PRODUCT CHANGE NOTIFICATION

#PCN-TT-C89F-15

Business Unit	Product Line Code	Type of Change	Action	Date of issue
TT	CL1	Electrical	Notify Distributors and Field	1/12/2016

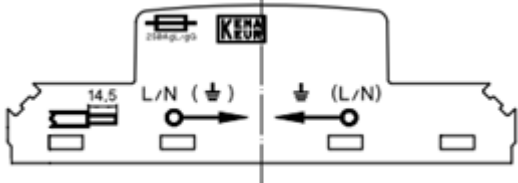
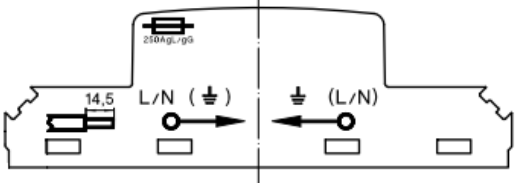
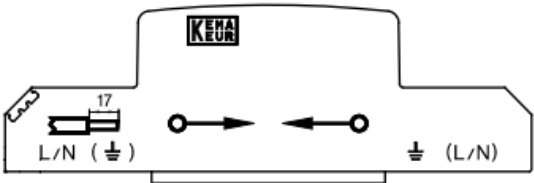
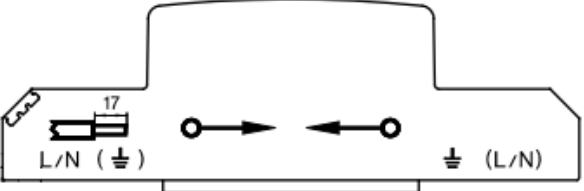
- Short circuit current rating, (ISCCR):
For FLT 25-400, FLT 60-400 and FLT 35-260: down-rated from 25 kA to 2,5 kA
- TOV-behavior at UT (L-PEN):
For FLT 60-400: improved from 400 V (5s) to 440 V (5s)
